**EPRI REVIEW OF MILLSTONE UNIT 2 DISSIMILAR METAL WELD
WALKDOWN INFORMATION**

INTERNAL REPORT, IR-2007-277

JUNE 2007

**DOMINION NUCLEAR CONNECTICUT, INC.
MILLSTONE POWER STATION UNIT 2**

Figure 3-3
Reactor Coolant Pump Inlet Nozzle P-4-C-1 Millstone Unit 2 Profile and Coverage
Drawings of 45°RL

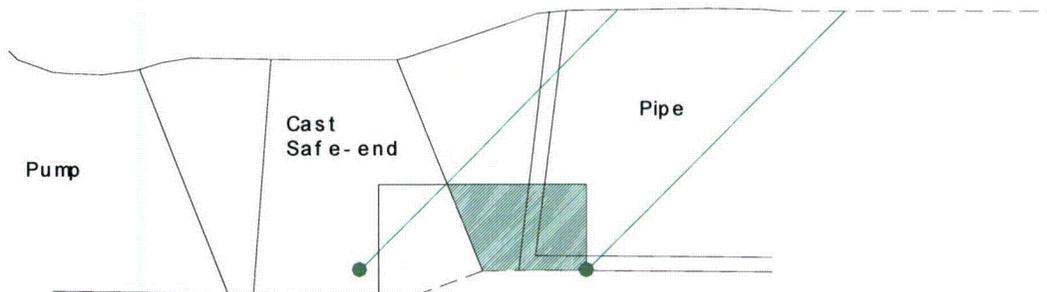
Code volume area is 3.49 square inches

Estimated obtainable area covered by 45° RL is 1.99 square inches

Estimated percent covered by 45° RL is 57%

Search unit size used – 2(24x42mm) (60x60mm) footprint

Exit point to front of search unit dimension is 1.10 inches

Exit point to rear of search unit dimension is 1.26 inches

Figure 3-4
Reactor Coolant Pump Inlet Nozzle P-4-C-1 Millstone Unit 2 Profile and Coverage
Drawings of 60°RL

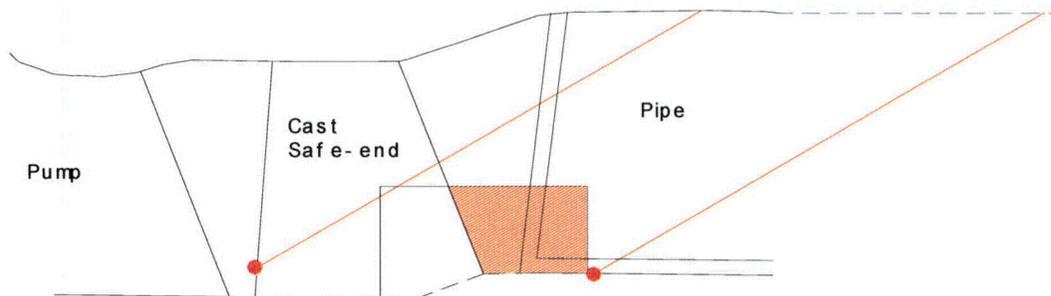
Code volume area is 3.49 square inches

Estimated obtainable area covered by 60° RL is 1.99 square inches

Estimated percent covered by 60° RL is 57%

Search unit size used – 2(24x42mm) (60x60mm) footprint

Exit point to front of search unit dimension is 1.15 inches

Exit point to rear of search unit dimension is 1.21 inches

Figure 3-5
Reactor Coolant Pump Inlet Nozzle P-4-C-1 Millstone Unit 2 Combined Axial Coverage of 45/60°RL

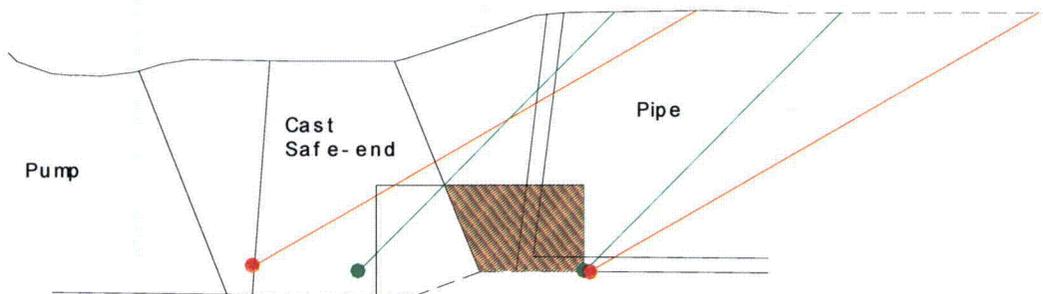
Area covered by both angles is 1.99 square inches, 57%.

Figure 3-6
Reactor Coolant Pump Inlet Nozzle P-4-C-1 Millstone Unit 2 Profile and Circ Coverage for 45°RL

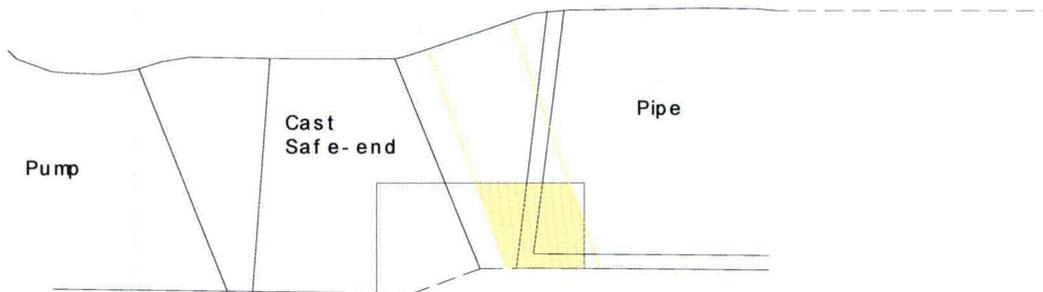
Code volume area is 3.49 square inches

Estimated obtainable area covered by 45° RL is 1.45 square inches

Estimated percent covered by 45° RL is 41%

Search unit size used – 2(24x42mm) (60x60mm) footprint

Centerline to edge of transducer dimension is 0.60 inches

Figure 3-9
Reactor Coolant Pump Inlet Nozzle P-13-C-1 Millstone Unit 2 Profile and Coverage Drawings of 45°RL

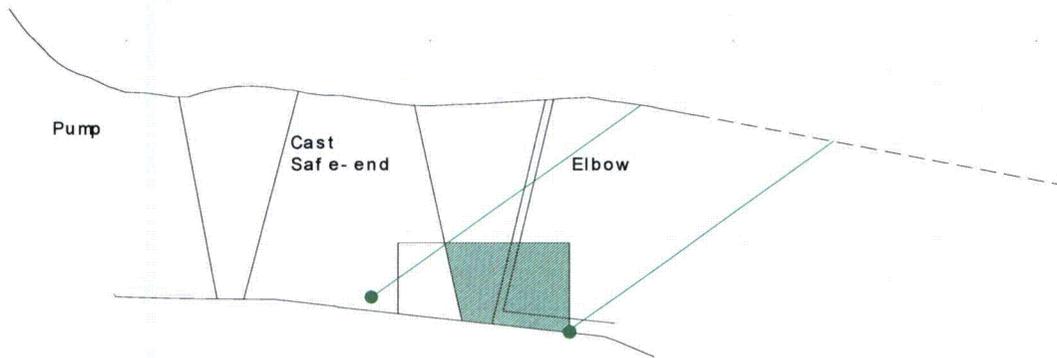
Code volume area is 3.27 square inches
Estimated obtainable area covered by 45° RL is 2.30 square inches
Estimated percent covered by 45° RL is 70%
Search unit size used – 2(24x42mm) (60x60mm) footprint
Exit point to front of search unit dimension is 1.10 inches
Exit point to rear of search unit dimension is 1.26 inches

Figure 3-10
Reactor Coolant Pump Inlet Nozzle P-13-C-1 Millstone Unit 2 Profile and Coverage Drawings of 60°RL

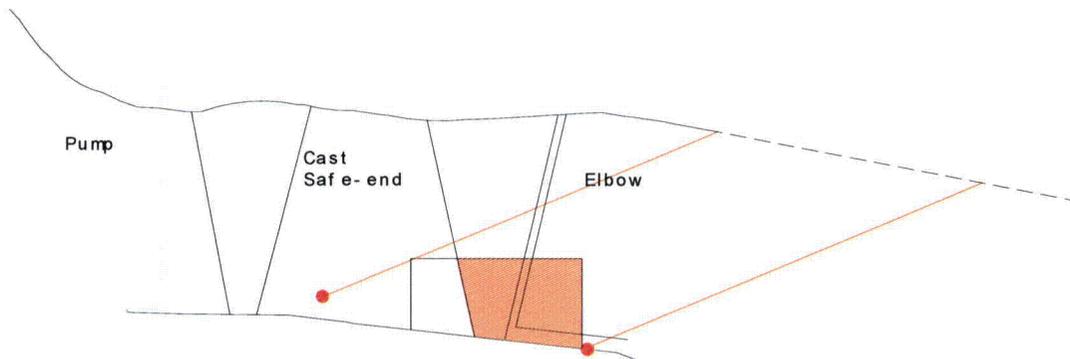
Code volume area is 3.27 square inches
Estimated obtainable area covered by 60° RL is 2.30 square inches
Estimated percent covered by 60° RL is 70%
Search unit size used – 2(24x42mm) (60x60mm) footprint
Exit point to front of search unit dimension is 1.15 inches
Exit point to rear of search unit dimension is 1.21 inches

Figure 3-11
Reactor Coolant Pump Inlet Nozzle P-13-C-1 Millstone Unit 2 Combined Axial Coverage of 45/60°RL

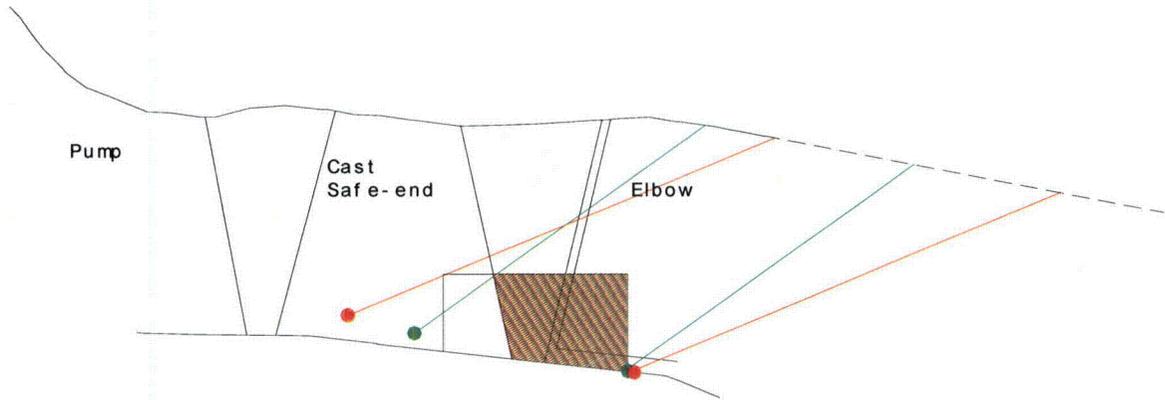
Area covered by both angles is 2.30 square inches, 70%.

Figure 3-12
Reactor Coolant Pump Inlet Nozzle P-13-C-1 Millstone Unit 2 Profile and Circ Coverage for 45°RL

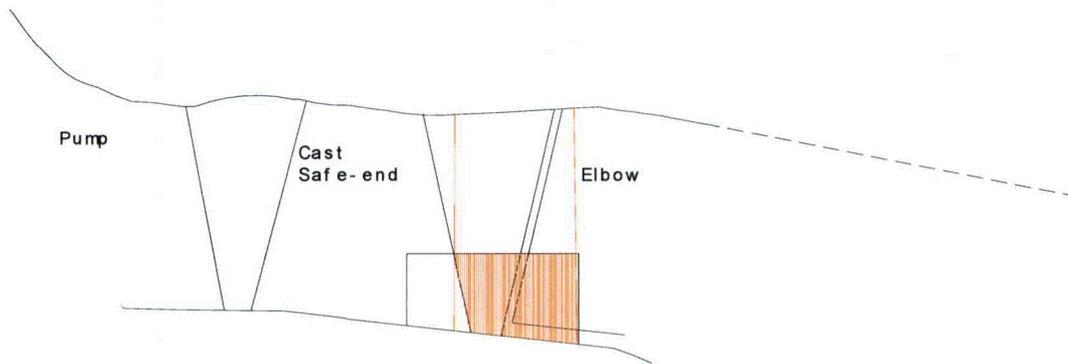
Code volume area is 3.27 square inches
 Estimated obtainable area covered by 45° RL is 2.28 square inches
 Estimated percent covered by 35° RL is 70%
 Search unit size used – 2(24x42mm) (60x60mm) footprint
 Centerline to edge of transducer dimension is 0.60 inches

Figure 3-15
Reactor Coolant Pump Inlet Nozzle P-17-C-1 Millstone Unit 2 Profile and Coverage
Drawings of 45°RL

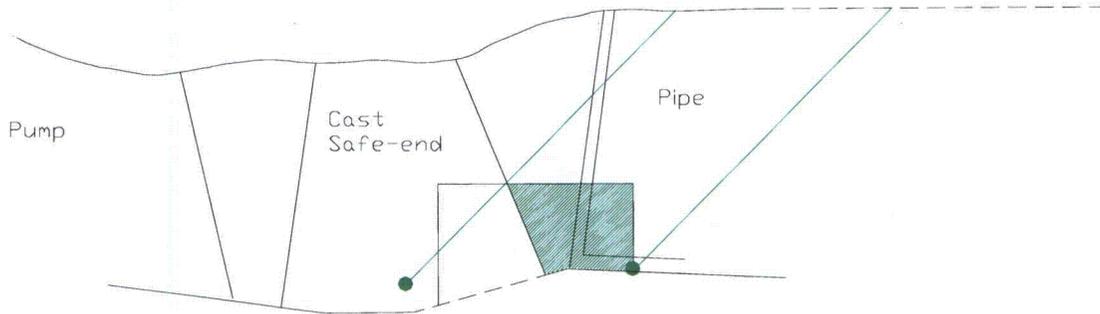
Code volume area is 3.64 square inches
Estimated obtainable area covered by 45° RL is 1.83 square inches
Estimated percent covered by 45° RL is 50%
Search unit size used – 2(24x42mm) (60x60mm) footprint
Exit point to front of search unit dimension is 1.10 inches
Exit point to rear of search unit dimension is 1.26 inches

Figure 3-16
Reactor Coolant Pump Inlet Nozzle P-17-C-1 Millstone Unit 2 Profile and Coverage
Drawings of 60°RL

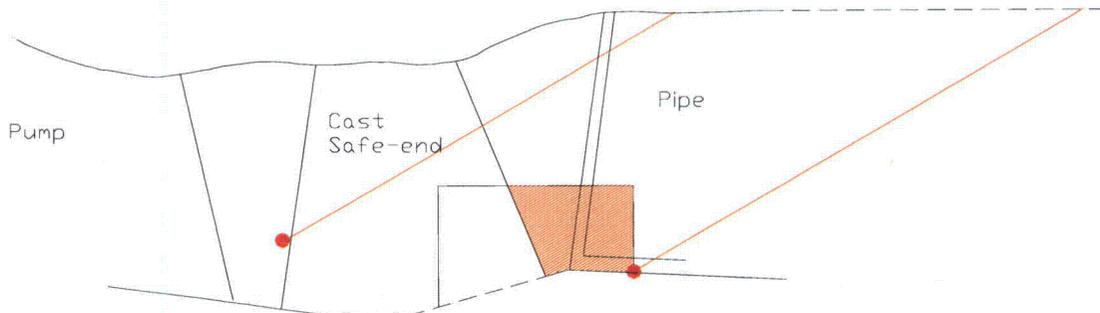
Code volume area is 3.64 square inches
Estimated obtainable area covered by 60° RL is 1.83 square inches
Estimated percent covered by 60° RL is 50%
Search unit size used – 2(24x42mm) (60x60mm) footprint
Exit point to front of search unit dimension is 1.15 inches
Exit point to rear of search unit dimension is 1.21 inches

Figure 3-17
Reactor Coolant Pump Inlet Nozzle P-17-C-1 Millstone Unit 2 Combined Axial Coverage of 45/60°RL

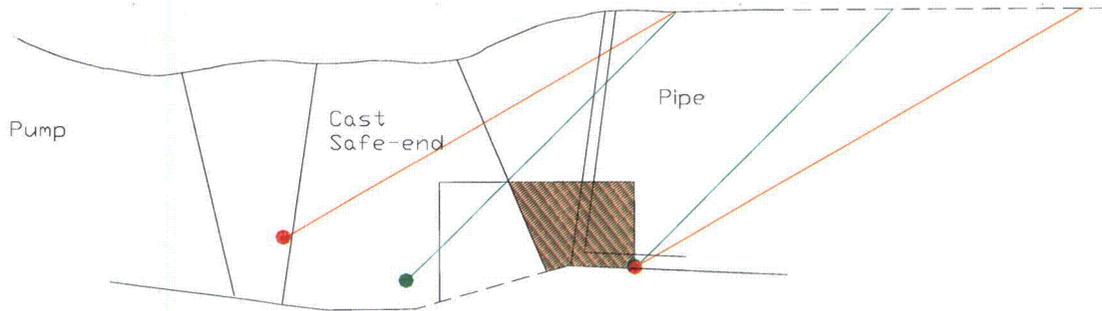
Area covered by both angles is 1.83 square inches, 50%.

Figure 3-18
Reactor Coolant Pump Inlet Nozzle P-17-C-1 Millstone Unit 2 Profile and Circ Coverage for 45°RL

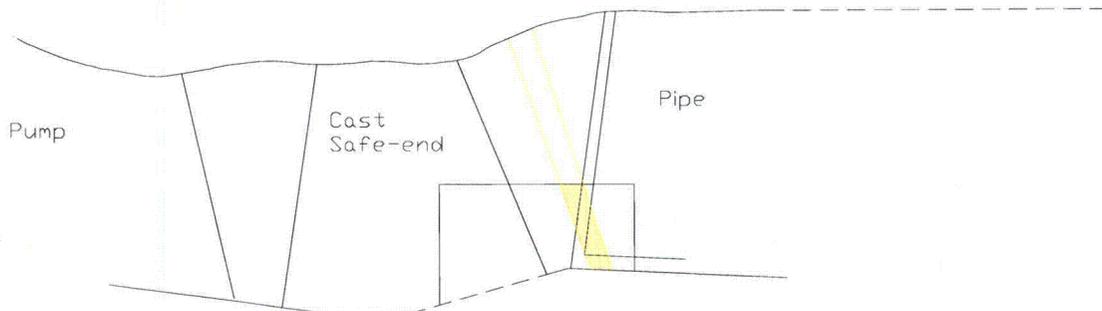
Code volume area is 3.64 square inches

Estimated obtainable area covered by 45° RL is 0.37 square inches

Estimated percent covered by 45° RL is 10%

Search unit size used – 2(24x42mm) (30x60mm) footprint

Centerline to edge of transducer dimension is 0.65 inches

Figure 4-3
Reactor Coolant Pump Outlet Nozzle P-5-C-3 Millstone Unit 2 Profile and Coverage
Drawings of 45°RL

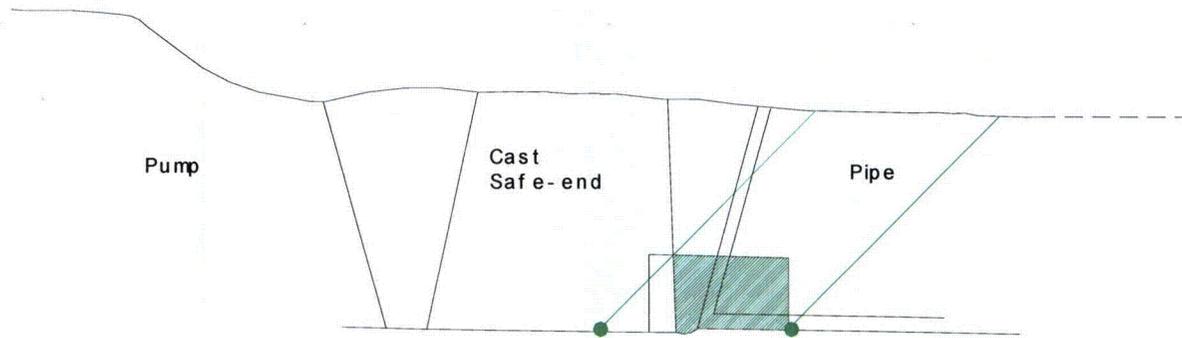
Code volume area is 1.92 square inches
Estimated obtainable area covered by 45° RL is 1.55 square inches
Estimated percent covered by 45° RL is 81%
Search unit size used – 2(24x42mm) (60x60mm) footprint
Exit point to front of search unit dimension is 1.10 inches
Exit point to rear of search unit dimension is 1.26 inches

Figure 4-4
Reactor Coolant Pump I Outlet Nozzle P-5-C-3 Millstone Unit 2 Profile and Coverage
Drawings of 60°RL

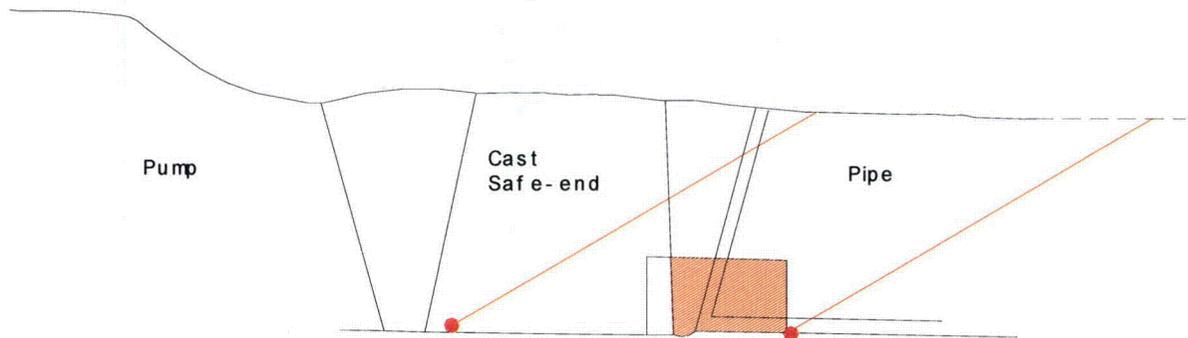
Code volume area is 1.92 square inches
Estimated obtainable area covered by 60° RL is 1.55 square inches
Estimated percent covered by 60° RL is 81%
Search unit size used – 2(24x42mm) (60x60mm) footprint
Exit point to front of search unit dimension is 1.15 inches
Exit point to rear of search unit dimension is 1.21 inches

Figure 4-5
Reactor Coolant Pump Outlet Nozzle P-5-C-3 Millstone Unit 2 Combined Axial Coverage of 45/60°RL

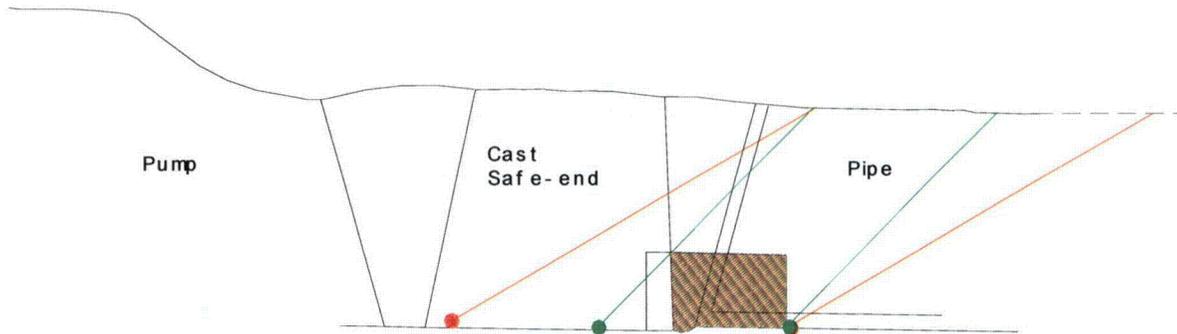
Area covered by both angles is 1.55 square inches, 81%.

Figure 4-6
Reactor Coolant Pump Outlet Nozzle P-5-C-3 Millstone Unit 2 Profile and Circ Coverage for 45°RL

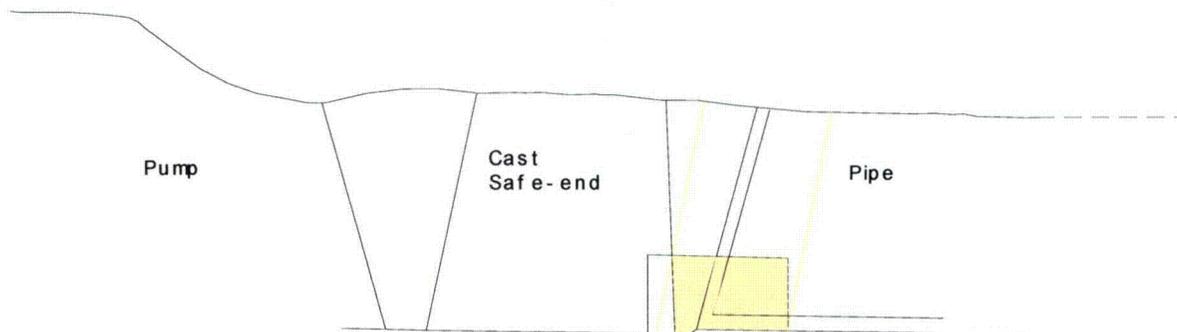
Code volume area is 1.92 square inches
 Estimated obtainable area covered by 45° RL is 1.55 square inches
 Estimated percent covered by 45° RL is 81%
 Search unit size used – 2(24x42mm) (60x60mm) footprint
 Exit point to front of search unit dimension is 1.10 inches
 Exit point to rear of search unit dimension is 1.26 inches

Figure 4-9
Reactor Coolant Pump Outlet Nozzle P-9-C-3 Millstone Unit 2 Profile and Coverage
Drawings of 45°RL

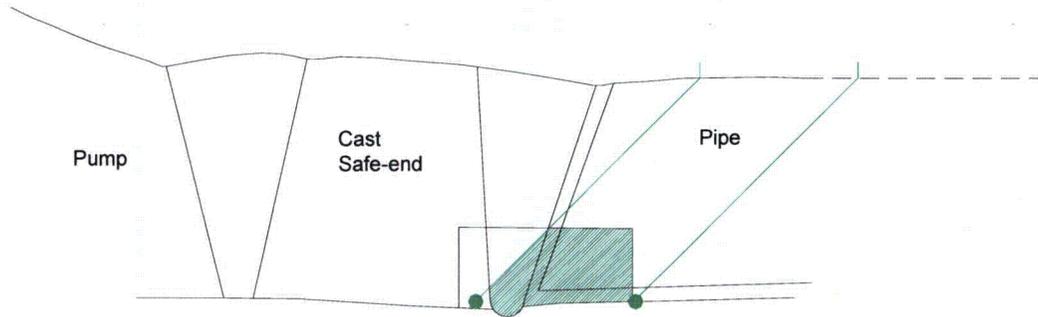
Code volume area is 2.45 square inches
Estimated obtainable area covered by 45° RL is 1.66 square inches
Estimated percent covered by 45° RL is 68%
Search unit size used – 2(24x42mm) (60x60mm) footprint
Exit point to front of search unit dimension is 1.10 inches
Exit point to rear of search unit dimension is 1.26 inches

Figure 4-10
Reactor Coolant Pump Outlet Nozzle P-9-C-3 Millstone Unit 2 Profile and Coverage
Drawings of 60°RL

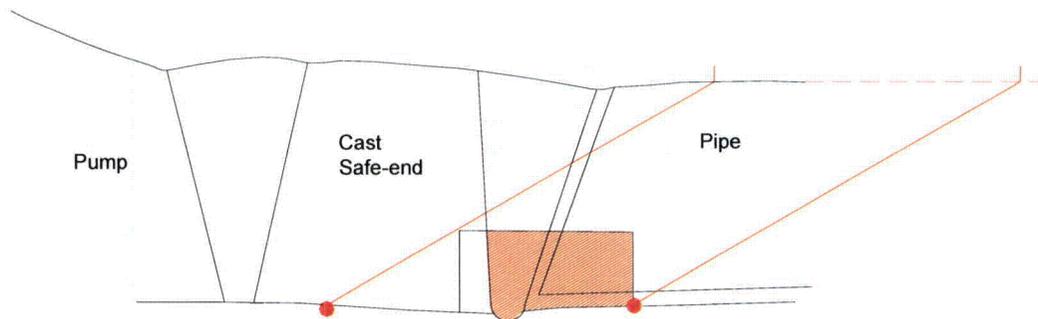
Code volume area is 2.45 square inches
Estimated obtainable area covered by 60° RL is 2.02 square inches
Estimated percent covered by 60° RL is 82%
Search unit size used – 2(24x42mm) (60x60mm) footprint
Exit point to front of search unit dimension is 1.15 inches
Exit point to rear of search unit dimension is 1.21 inches

Figure 4-11
Reactor Coolant Pump Outlet Nozzle P-9-C-3 Millstone Unit 2 Combined Axial Coverage of 45/60°RL

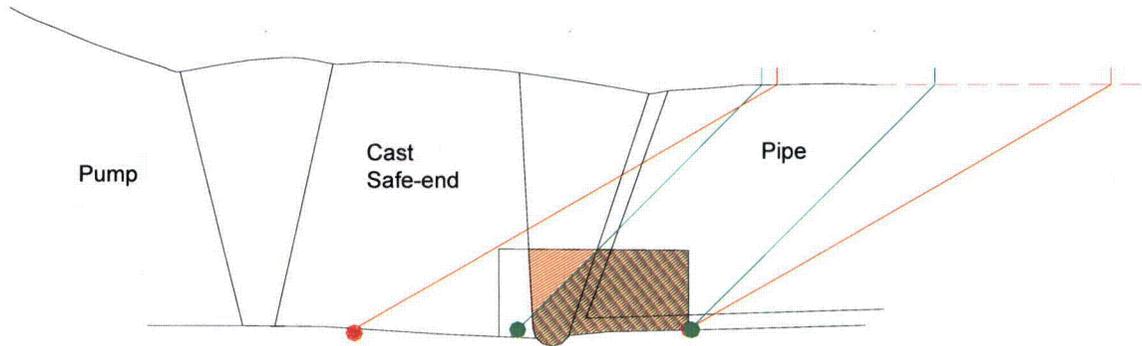
Area covered by both angles is 1.66 square inches, 68%.

Figure 4-12
Reactor Coolant Pump Outlet Nozzle P-9-C-3 Millstone Unit 2 Profile and Circ Coverage for 45°RL

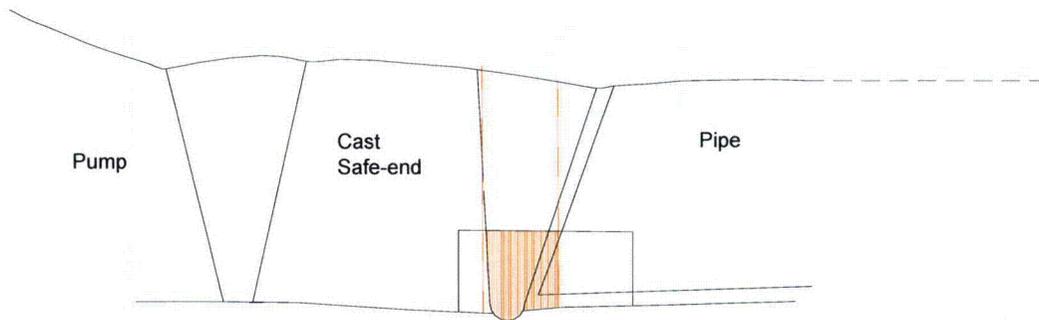
Code volume area is 2.45 square inches
 Estimated obtainable area covered by 45° RL is 1.04 square inches
 Estimated percent covered by 45° RL is 68%
 Search unit size used – 2(24x42mm) (60x60mm) footprint
 Exit point to front of search unit dimension is 1.10 inches
 Exit point to rear of search unit dimension is 1.26 inches

Figure 4-15
Reactor Coolant Pump Outlet Nozzle P-14-C-3 Millstone Unit 2 Profile and Coverage
Drawings of 45°RL

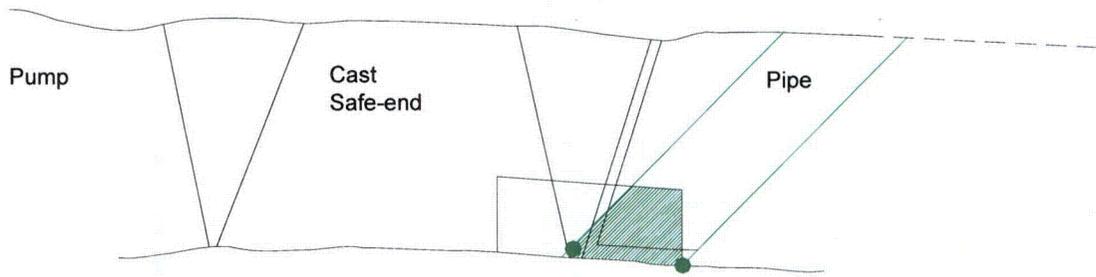
Code volume area is 2.09 square inches

Estimated obtainable area covered by 45° RL is 0.97 square inches

Estimated percent covered by 45° RL is 46%

Search unit size used – 2(24x42mm) (60x60mm) footprint

Exit point to front of search unit dimension is 1.10 inches

Exit point to rear of search unit dimension is 1.26 inches

Figure 4-16
Reactor Coolant Pump Outlet Nozzle P-14-C-3 Millstone Unit 2 Profile and Coverage
Drawings of 60°RL

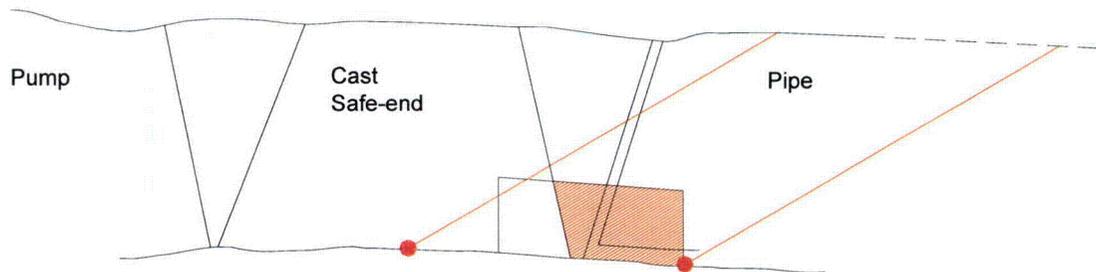
Code volume area is 2.09 square inches

Estimated obtainable area covered by 60° RL is 1.38 square inches

Estimated percent covered by 60° RL is 66%

Search unit size used – 2(24x42mm) (60x60mm) footprint

Exit point to front of search unit dimension is 1.15 inches

Exit point to rear of search unit dimension is 1.21 inches

Figure 4-17
Reactor Coolant Pump Outlet Nozzle P-14-C-3 Millstone Unit 2 Combined Axial Coverage of 45/60°RL

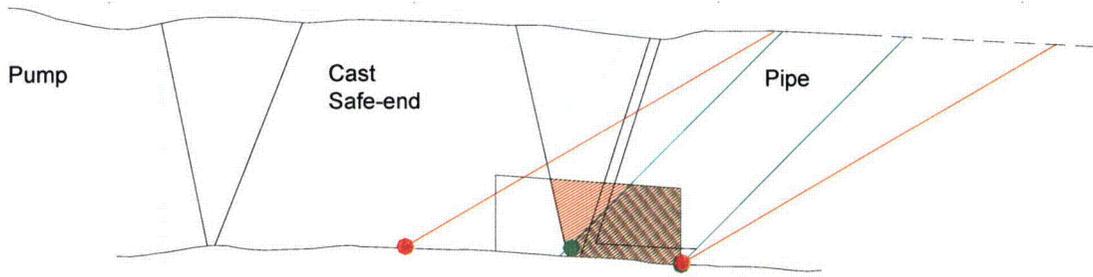
Area covered by both angles is 0.97 square inches, 46%.

Figure 4-18
Reactor Coolant Pump Outlet Nozzle P-14-C-3 Millstone Unit 2 Profile and Circ Coverage for 45°RL

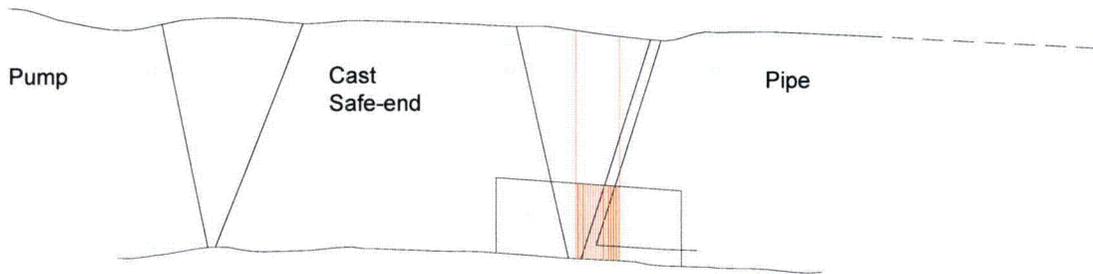
Code volume area is 2.09 square inches
 Estimated obtainable area covered by 45° RL is 0.49 square inches
 Estimated percent covered by 45° RL is 23%
 Search unit size used – 2(24x42mm) (60x60mm) footprint
 Exit point to front of search unit dimension is 1.10 inches
 Exit point to rear of search unit dimension is 1.26 inches

Figure 4-21
Reactor Coolant Pump Outlet Nozzle P-18-C-3 Millstone Unit 2 Profile and Coverage
Drawings of 45°RL

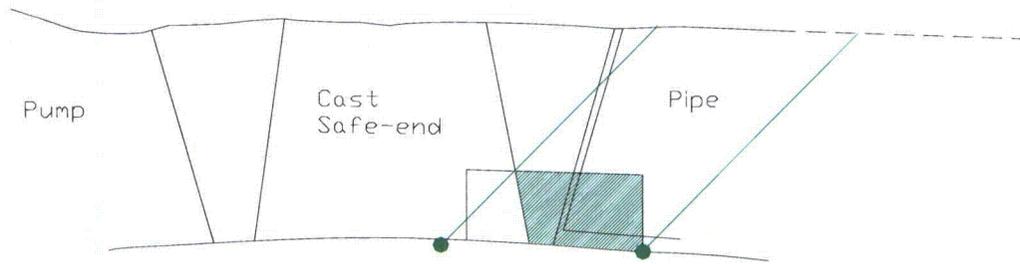
Code volume area is 2.08 square inches
Estimated obtainable area covered by 45° RL is 1.44 square inches
Estimated percent covered by 45° RL is 69%
Search unit size used – 2(24x42mm) (60x60mm) footprint
Exit point to front of search unit dimension is 1.10 inches
Exit point to rear of search unit dimension is 1.26 inches

Figure 4-22
Reactor Coolant Pump Outlet Nozzle P-18-C-3 Millstone Unit 2 Profile and Coverage
Drawings of 60°RL

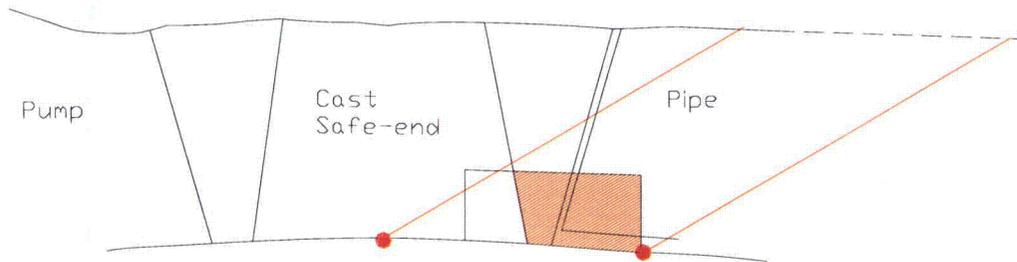
Code volume area is 2.08 square inches
Estimated obtainable area covered by 60° RL is 1.44 square inches
Estimated percent covered by 60° RL is 69%
Search unit size used – 2(24x42mm) (60x60mm) footprint
Exit point to front of search unit dimension is 1.15 inches
Exit point to rear of search unit dimension is 1.21 inches

Figure 4-23
Reactor Coolant Pump Outlet Nozzle P-14-C-3 Millstone Unit 2 Combined Axial Coverage of 45/60°RL

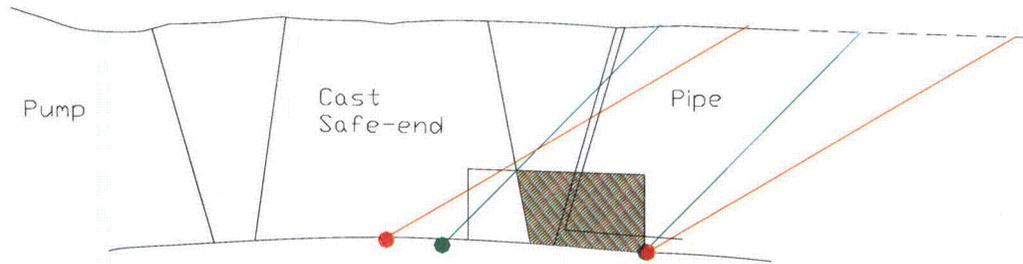
Area covered by both angles is 1.44 square inches, 69%.

Figure 4-24
Reactor Coolant Pump Outlet Nozzle P-18-C-3 Millstone Unit 2 Profile and Circ Coverage for 45°RL

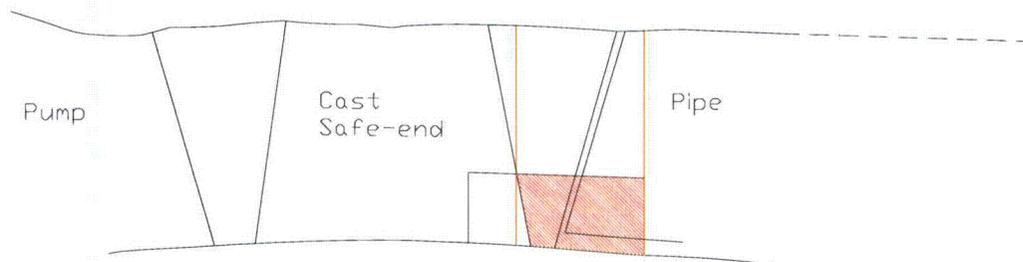
Code volume area is 2.08 square inches

Estimated obtainable area covered by 45° RL is 1.44 square inches

Estimated percent covered by 45° RL is 69%

Search unit size used – 2(24x42mm) (60x60mm) footprint

Exit point to front of search unit dimension is 1.10 inches

Exit point to rear of search unit dimension is 1.26 inches
